9.5 Other Auxiliary Systems

The information in this section of the reference ABWR DCD, including all subsections, tables, and figures, as modified by the STP Nuclear Operating Company Application to Amend the Design Certification rule for the U.S. Advanced Boiling Water Reactor (ABWR), "ABWR STP Aircraft Impact Assessment (AIA) Amendment Revision 3," dated September 23, 2010 is incorporated by reference with the following departures and supplements.

STD DEP T1 3.4-1	STD DEP 9.5-2 (Figure 9.5-3, replaced entire figure)
STP DEP 1.1-2 (Figures 9.5-2, 9.5-4 and 9.5-5)	STD DEP 9.5-3
STP DEP 1.2-2 (Table 9.5-5)	STD DEP 9.5-4
STD DEP 8.3-1	STP DEP 9.5-6 (Figure 9.5-6)
STD DEP 9.4-2 (Table 9.5-5)	STP DEP 9.5-7 (Table 9.5-5)
STD DEP 9.5-1	STD DEP Admin

Figure 9.5-3 Lower Drywell Flooder System Arrangement/Configuration

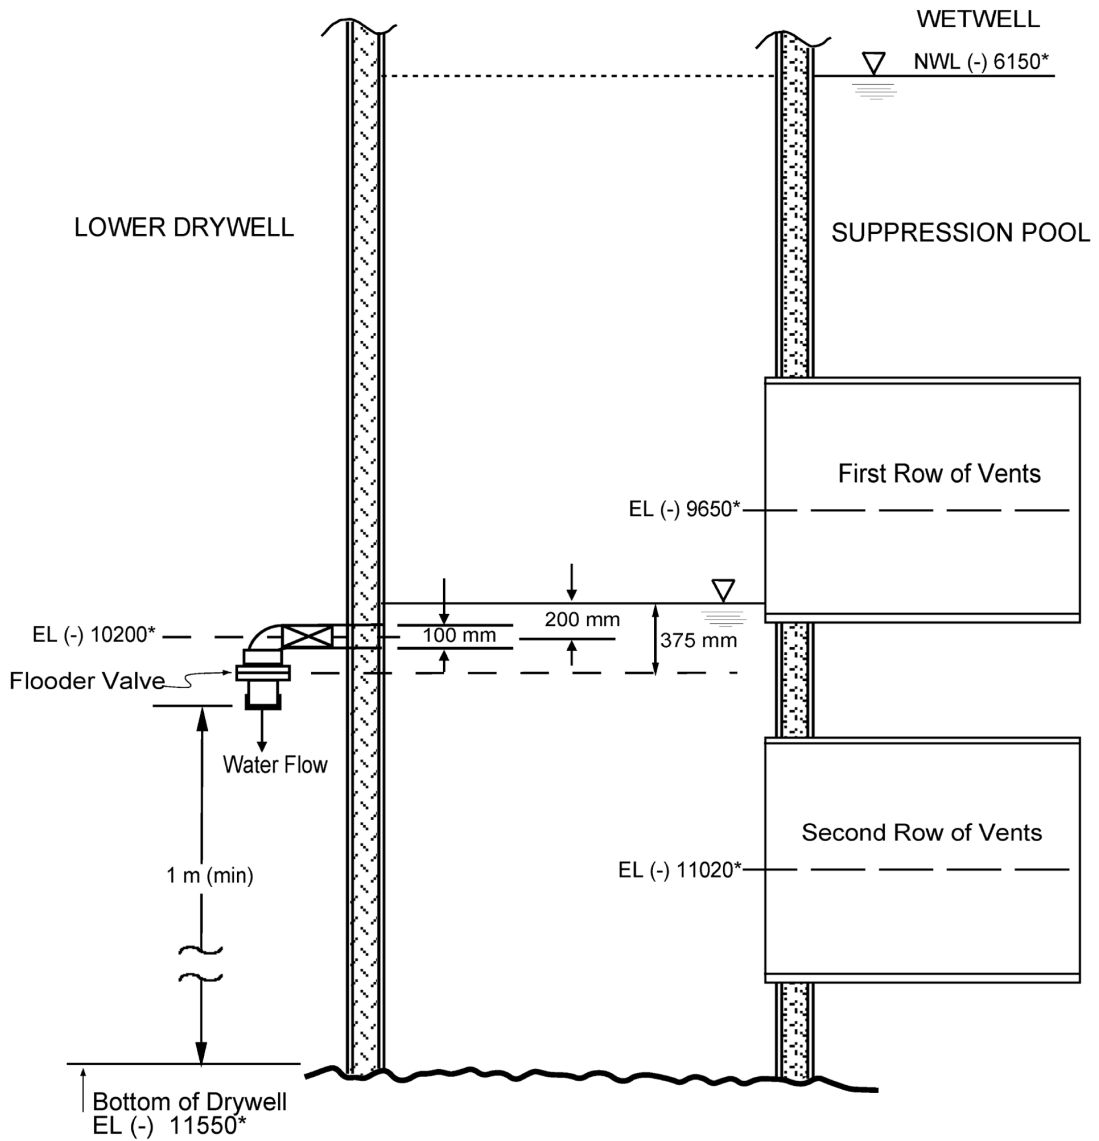
The LDF, shown schematically in Figure 9.5-3, provides a flow path for suppression pool water into the lower drywell area during severe accident scenario that leads to core meltdown, vessel failure, and deposition of molten corium on the lower drywell floor. Molten corium is a molten mixture of fuel, reactor internals, the vessel bottom head and control rod drive components. The flow path is opened when the lower drywell airspace temperature reaches 260°C.

The LDF consists of ten pipes that run from the vertical pedestal vents into the lower drywell. Each pipe ~~contains~~ has an isolation valve and a fusible plug valve connected to the end of the pipe that extends into the lower drywell ~~by a flange~~. The fusible plug valves open when the drywell air space ~~(and subsequently the fusible plug)~~ temperature reaches 260°C. When the fusible plug valves open, a minimum of 10.5 L/s of suppression pool water will be supplied through each flooder pipe (105 L/s total) to the lower drywell to quench the corium, flood the lower drywell and remove corium decay heat, which is estimated at 1% of rated thermal power. The flow rate is based on a minimum hydrostatic head of 200 mm above the flooder pipe inlet centerline and takes the frictional losses through the flooder pipe and fusible plug valve into account.
